City of Plymouth Planning Commission

Regular Meeting Agenda

**Special Land Use and
Site Plan Review
For
Plymouth, Michigan**

Applicant:	Bryan Bender Fortisnet Lease 30445 Northwestern Highway Farmington Hills, MI 48334
Project Name:	Scooter's Coffee Drive-Thru
Plan Date:	September 17, 2021
Location:	1490 W. Ann Arbor Road
Zoning:	ARC – Ann Arbor Road Corridor District
Action Requested:	Special Land Use and Site Plan Approval
Required Information:	Any deficiencies are noted in the report.

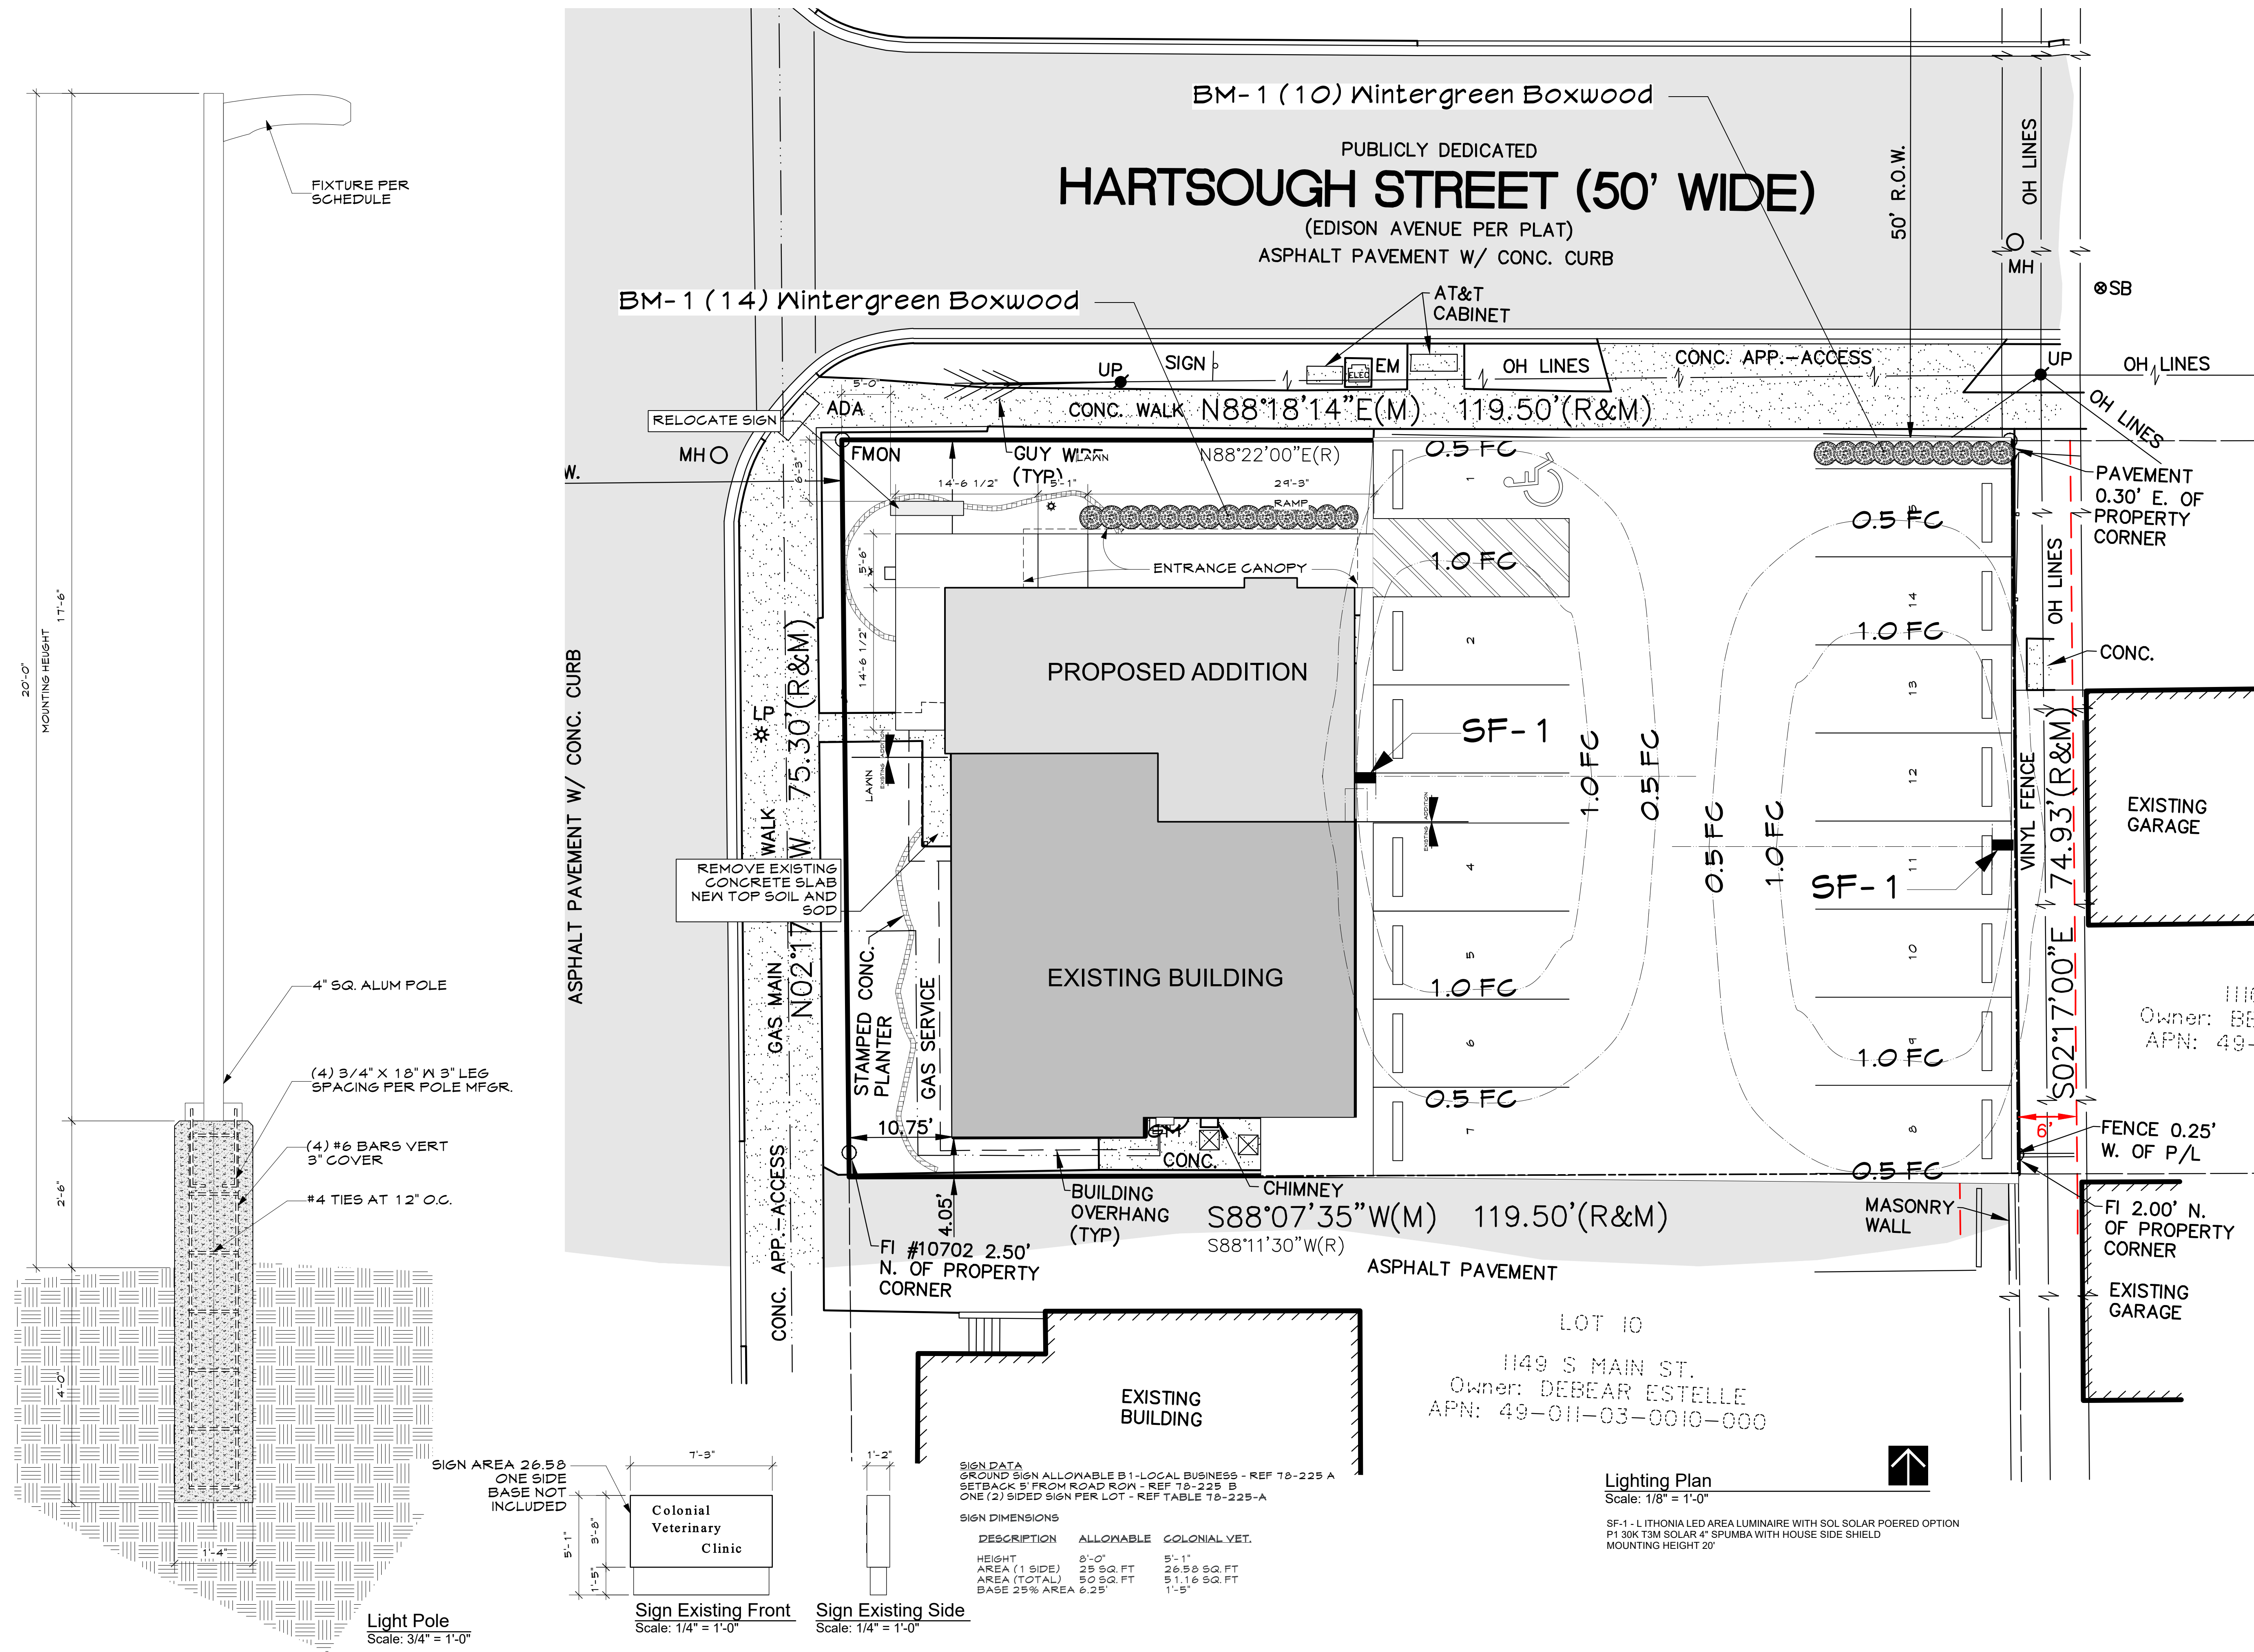
Sheet A0.2 shows the proposed sign to be located in the clear vision area. To be permissible, the sign must not exceed 30-inches in height. A sign detail is shown on Sheet A0.2. The sign is shown at 5.08 feet tall, which exceeds the maximum allowed in the clear vision zone. To keep this location and proposed sign, the applicant will need to obtain a variance.

The proposed lighting is shown on Sheet A0.2. This sheet proposes two new, pole-mounted light fixtures in the parking lot; one on the east side and one on the west side. The photometric information provided on this sheet shows the light levels meet the 0.1 maximum footcandles at the property line to the residential use to the east. The plans indicate that this fixture comes with a house-side shield, and the illustration implies that the fixture is downward facing. However, the applicant needs to provide information about whether the fixture is non-glare, color-corrected fixture, and that the lighting source is not directly visible from adjoining properties at the proposed height.

Parking lot lighting has been added to the project. Please see sheet A0.2

Please see sheet A0.2 for sign details
